OUTER DRIVE FORCE MAIN CATHODIC PROTECTION Contract No. BE20-082

ADDENDUM NO.: TWO

DATE ADDENDUM ISSUED: September 17, 2019

**FLANGE CONNECTION
 DETAILS**

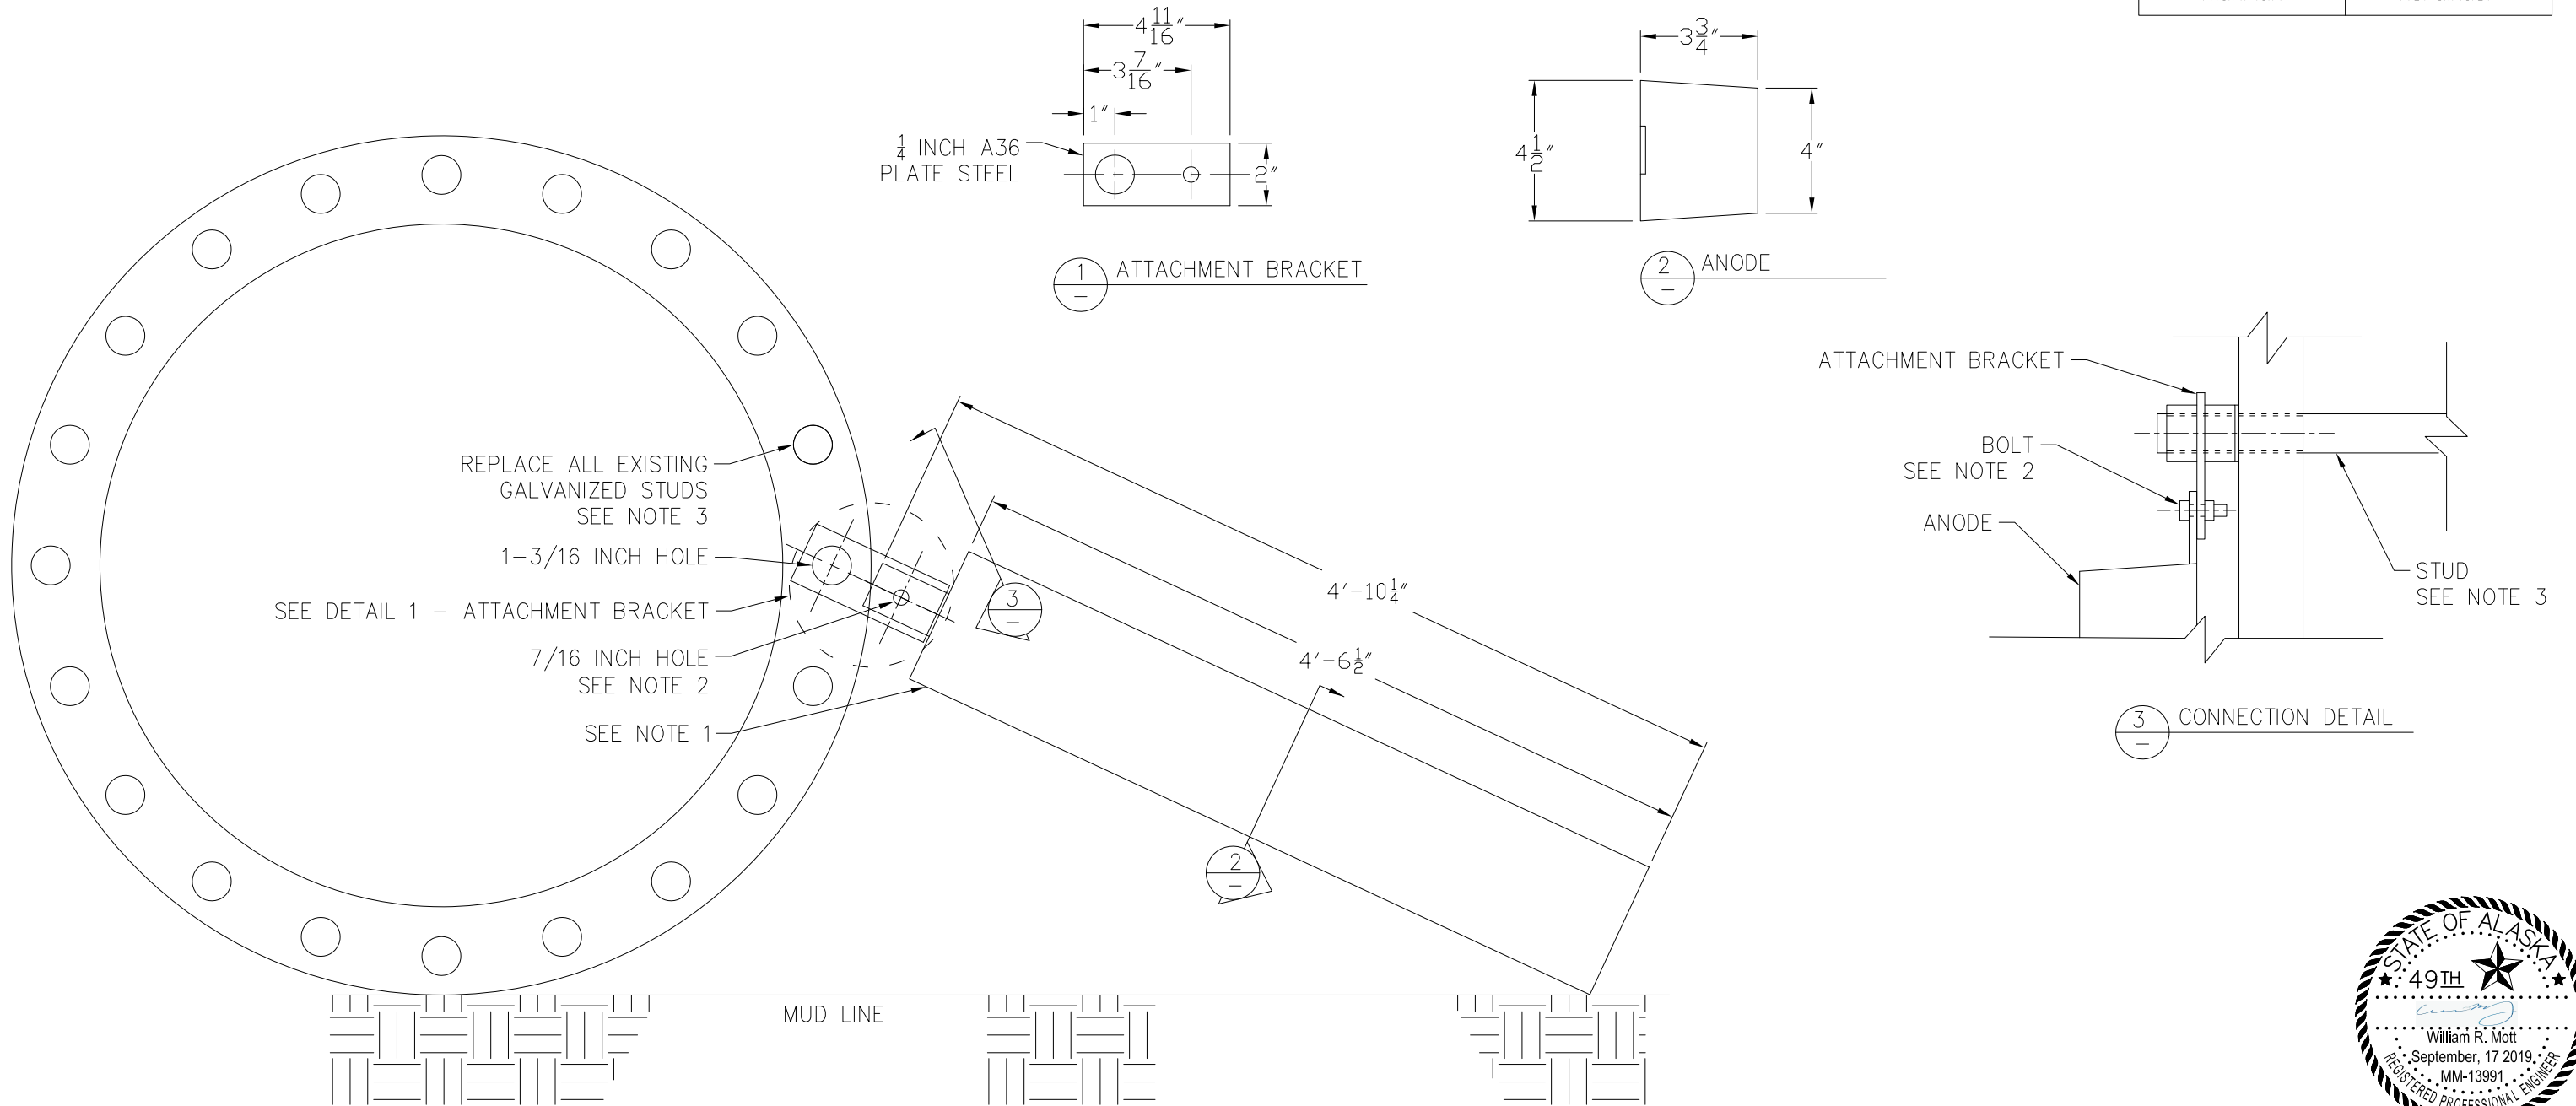
Question: *"The drawings indicate double nuts on the flange stud at the anode connection. Are double nuts installed on all the replaced flange studs? Or just for the attachment of the anode bracket?"*

Question: *"Is a washer required with the second nut to secure the attachment bracket?"*

Question: *"On Drawing 2 of 4 Note 2 indicates the hardware for the anode connection. There is not a washer or double nut detailed at the anode to bracket connection is a washer or double nut required here?"*

Question: *"The drawings specify A53 Steel used for the Anode bracket, as this is not a structural connection but a bonding connection can A36 steel be utilized?"*

Question: *"The anode specified (Farwest Corrosion 94FM) is a 94 lb anode. Page 2 of 4 of the plans Note 1 specifies a 37 lb. anode. Further the anode dimensions detailed are for a 94 lb anode. Can you provide clarification on the required anode weight intended?"*

Question: *“Drawings show the anodes having a flush end. Is a standard anode with tabs on both ends acceptable?”*

Question: *“In Regards to Anode Dimensions / The dimensions provided in the drawings for length and profile provide for a anode with calculating the volume of 23 lbs and do not align with the indicated weight requirements in the drawings notes or the referenced 94FM. Can you provide specific clarification on the required weight of the anode required and expected dimensions?”*

Item No. 1 **Replace** SHEET 2 of 4 – FLANGE CONNECTION DETAILS
with the attached SHEET 2 of 4 – FLANGE CONNECTION DETAILS

Response: The replacement studs should be just single nuts. The double nut is only necessary on the stud securing the anode bracket.

Response: A washer is not necessary but the contractor may add one if they prefer.

Response: A washer is not necessary but the contractor may add one if they prefer. The detail does show a double nut with the anode bracket between the two nuts.

Response: Yes, A36 Steel can be used.

Response: The anode should be a 94 lb. The drawing has been modified to reflect that change.

Response: The standard anodes typically come with tabs on each end. The design assumes that the contractor will purchase standard anodes and trim off the tab on the far end.

Response: The anode should be a 94 lb. The drawing has been modified to reflect that change.

1. ANODE WILL BE 94 LB. ALUMINUM FLUSH MOUNT ANODE (FARWEST CORROSION 94FM CORE OR EQUIVALENT).
2. BOLTS WILL BE WRENCH TIGHT, 1-1/2 INCH X 3/8 INCH A193 GR B7. NUTS WILL BE A194 GR 2H.
3. STUDS WILL BE 18 INCH X 1-1/8 INCH STAINLESS STEEL A320 GR B8M. NUTS WILL BE A194 GR 8M. WASHER WILL BE 316L. TORQUE to 424 FT-LBS.
4. CONTRACTOR TO PROVIDE CLEAR VIDEO DOCUMENTATION OF ANODE INSTALLATIONS AND FLANGE CONDITIONS
5. THE BOTTOM OF THE FLANGE MAY BE PARTIALLY BURIED IN SILT WHICH WILL NEED TO BE REMOVED TO CHANGE THE STUDS OUT.
6. FLANGE LOCATIONS:
 -58.2968047°, -134.4060941°
 -58.2941755°, -134.4023500°
 -58.2916186°, -134.3985354°
 DEPTH: 100-110' FROM MLLW 0.0'
7. BOLTS SHALL BE CHANGED OUT ONE AT A TIME
